METROPOLITAN AREA PLANNING
DEPARTMENT

Re: S/D97-83 -- One Step Final Plat of RIVERSIDE HEALTH SYSTEMS 2ND ADDITION

Re: S/D97-83 -- One Step Final Plat of RIVERSIDE HEALTH SYSTEMS 2ND ADDITION

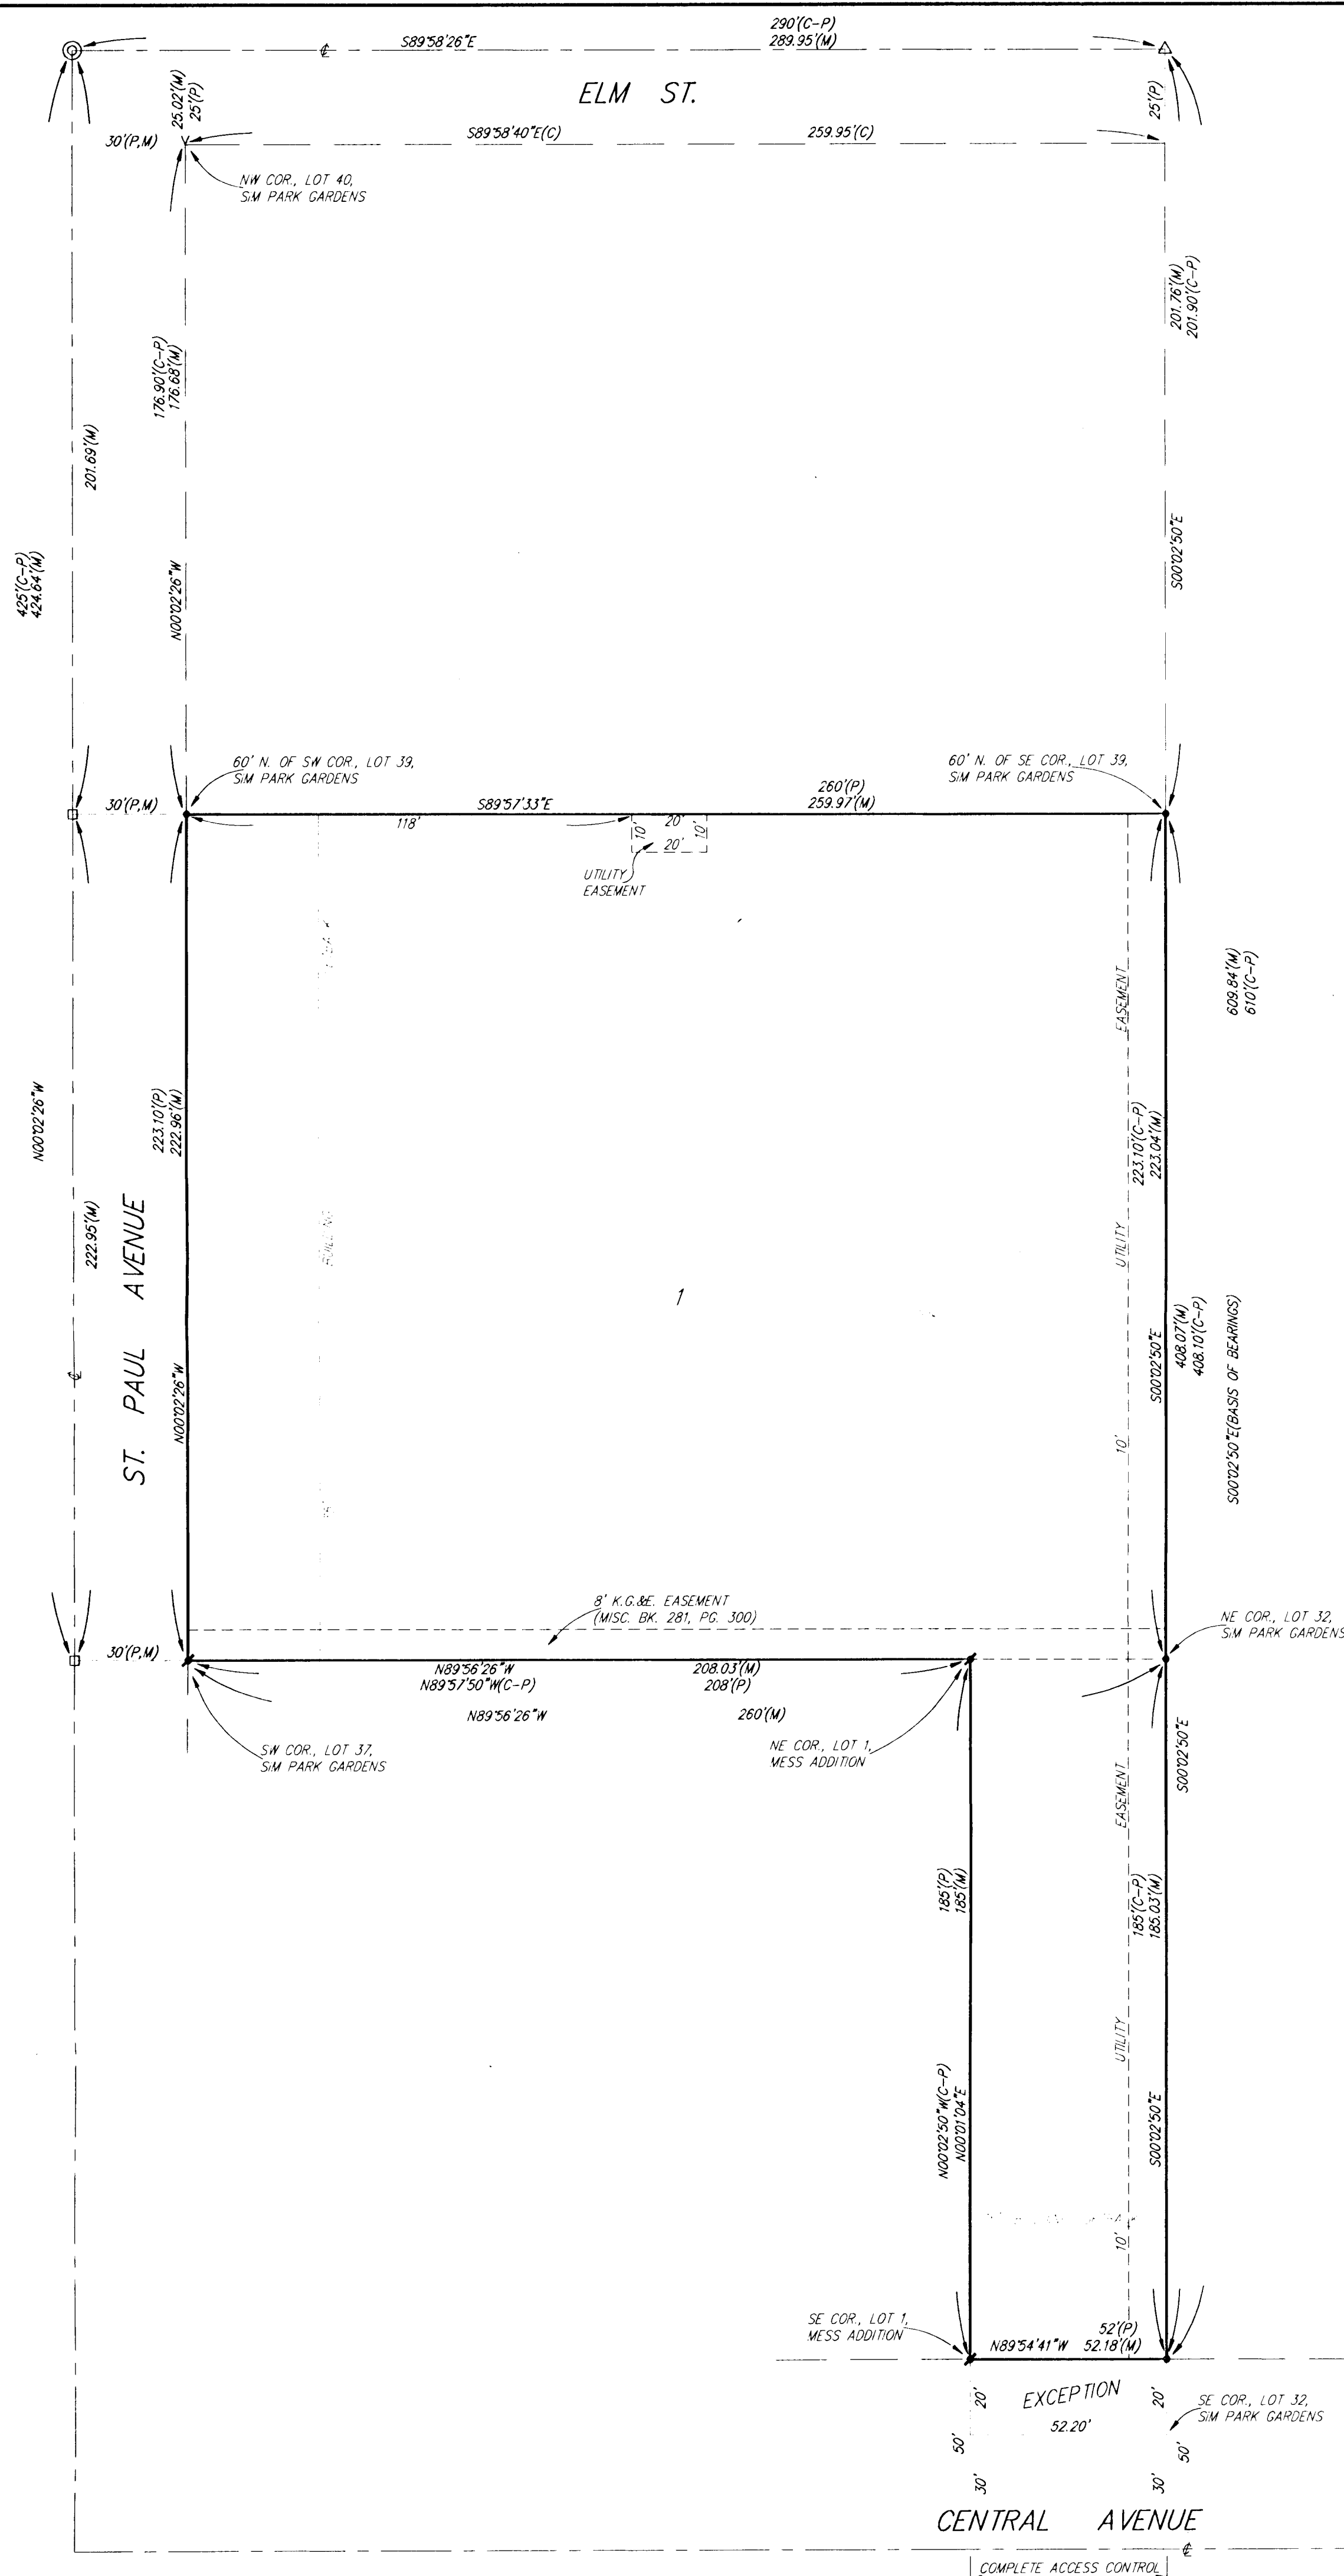
- C. A temporary easement will need to be established by separate instrument for the existing sanitary sewer line that is intended to be abandoned, unless the sewer line is abandoned before the plat is recorded. City Engineering requires a guarantee for the abandonment of the sewer line.

- D. Traffic Engineering needs to indicate the need, if any, for access controls. Traffic Engineering recommends complete access control along Central.

- F. The Subdivision Regulations require a 35-foot building setback from perimeter streets for commercial lots, which should be denoted on the final plat.

- G. As an office lot adjacent to a non-arterial street, the plat should designate a sidewalk along St. Paul Avenue, in accordance with the sidewalk ordinance.

- I. The distance from the property to the centerline of Central Avenue should be denoted on the plat.
- J. The applicant shall install or guarantee the installation of all utilities and facilities which are applicable and described in Article 8 of the MAPC Subdivision Regulations. (Water service and fire hydrants required by Article 8 for fire protection shall be as per the direction and approval of the Chief of the Fire Department.)

- P. The representatives from the utility companies should be prepared to comment on the need for any additional utility easements to be platted on this property. **The Southwestern Bell representative requests additional easements as denoted on the attached plat.**
